Decision Date: June 19, 2019

RE: Vesting Tentative Tract Map No.: 72825-CN
1806 North Gramercy Place
Central City North Planning Area
Related Case: DIR-2015-2766-DB-SPP & DIR-
2015-2766-DB-SPP-M1
Zone : R3-1
D. M. : 150A193
C. D. : 13 - O'Farrell
CEQA : ENV-2015-580-MND-REC1
Legal Description: Morgan's Replat of Lots 61 to
73 Inclusive Of Morgan's Hollywood Tract

TENTATIVE TRACT MAP 72825 FOR CONDOMINIUM PURPOSES

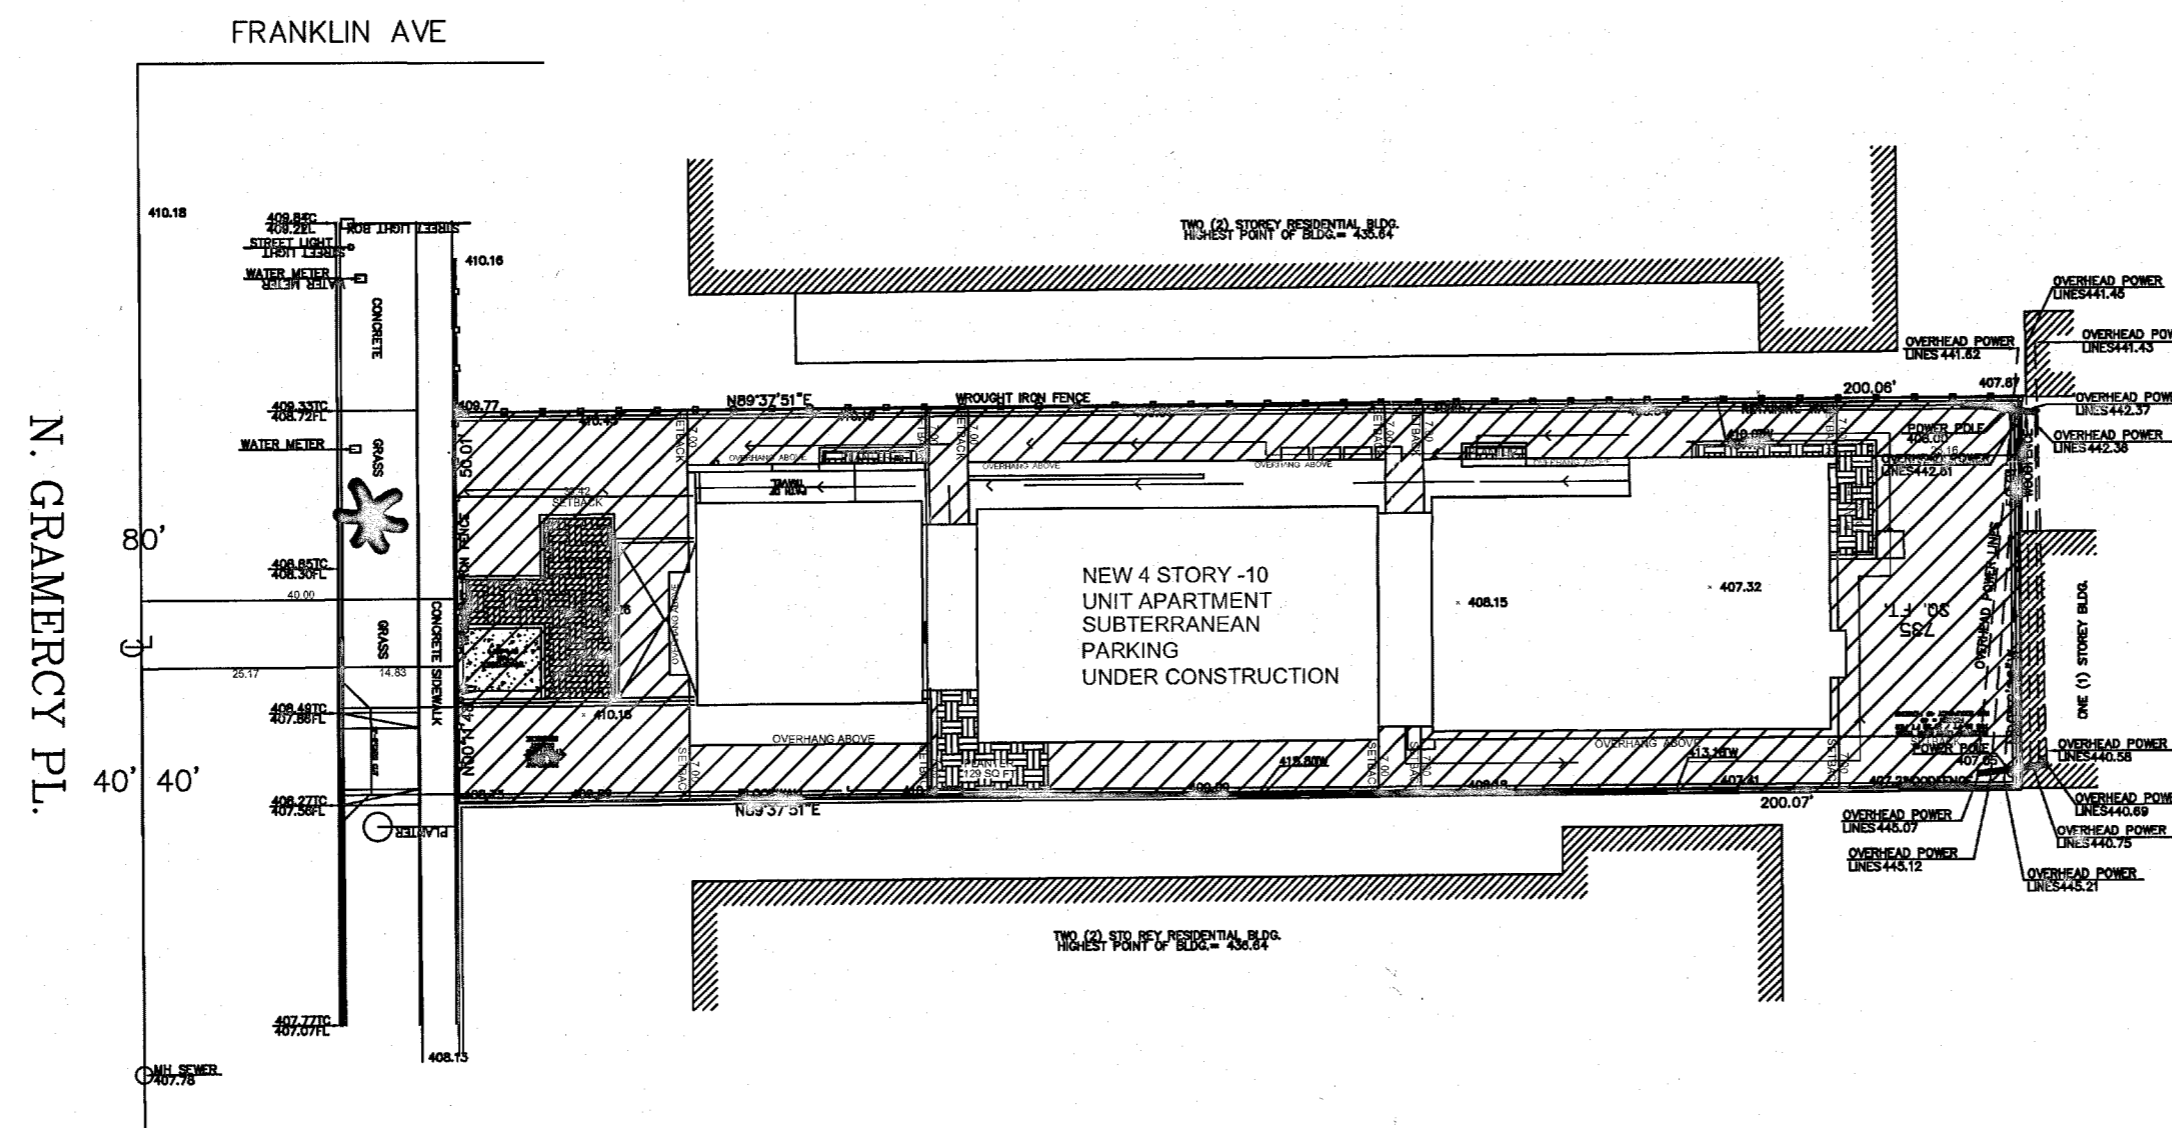
3. Show all street dedication as required by Bureau of Engineering and provide net lot area after all dedication. "Area" requirements shall be re-checked as per net lot area after street dedication. Front yard requirements shall be required to comply with current code as measured from new property lines after dedication.
4. The submitted Map does not comply with the front yard (30 ft. Building Line), requirement of the R3-1 Zone. Revise the Map to show compliance with the above requirement or obtain approval from the Department of City Planning.

There is a 30 ft. Building Line along Gramercy Place on this Subdivision.

The submitted Map may not comply with the number of parking spaces required by Section 12.21 A.4 (a) based on number of habitable rooms in each unit. If there are insufficient numbers of parking spaces, obtain approval from the Department of City Planning.

The submitted Map may not comply with the number of guest parking spaces required by the Advisory Agency.

Backup space for parking space with less than 26'-8" shall provide sufficient parking stall width and garage door opening width to comply with the current Zoning Code requirement.
